DOCUMENT CHANGE REQUEST

DCR number 568	Changes required for: General	Originator: Steve Thacker - ESCC
Date: 2010/01/12	Date sent: 2010/01/12	Organisation:
Status: IMPLEMENTED

Title:	Generic Specification for Discrete Semiconductor Components		
Number:	5000	Issue:	5

12.4 CHART F4 - QUALIFICATION AND PERIODIC TESTS

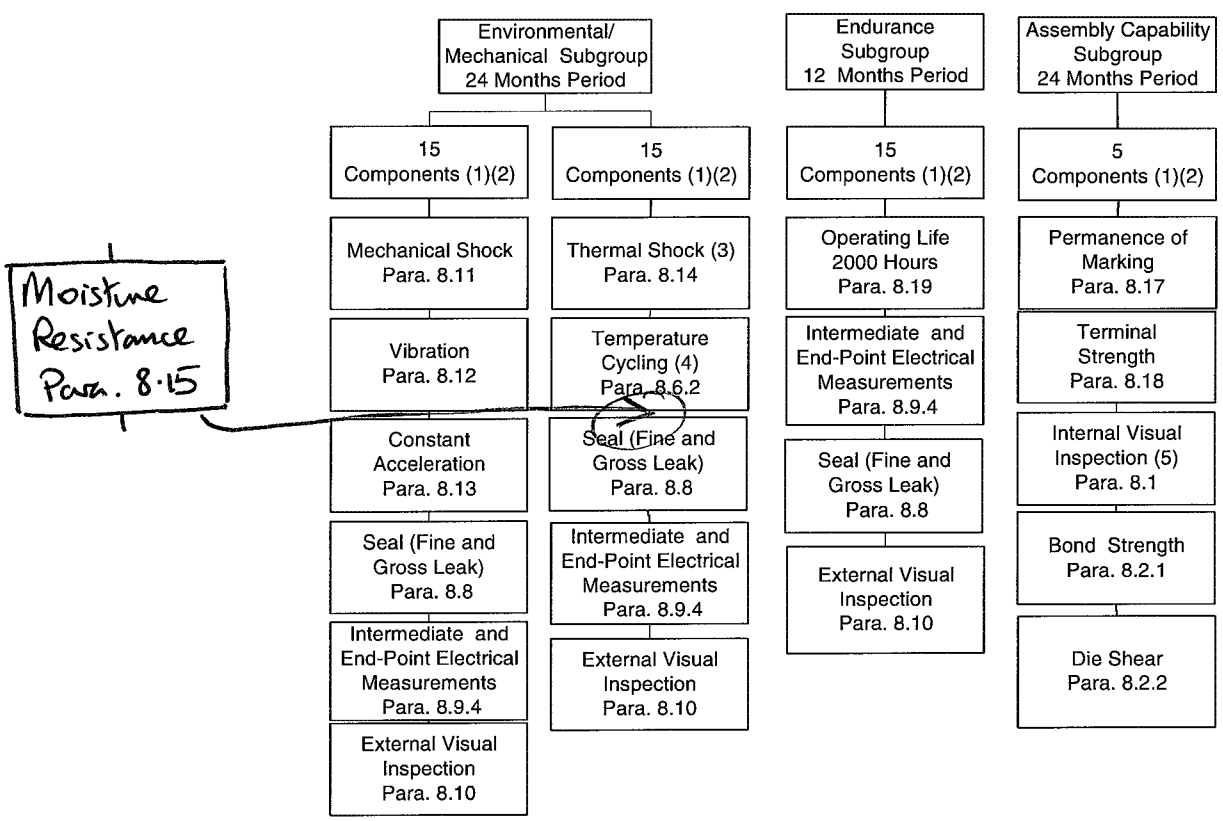
Chart F4
Add missing test box for Moisture Resistance, as follows (see attached mark-up), in The Environmental/Mechanical Subgroup (2nd column) between Temperature Cycling and Seal

---
Moisture
Resistance
Para. 8.15

This is an editorial error. The Moisture resistance test box in Chart F4 was wrongly removed during implementation of DCR399 on 5000 issue 3.
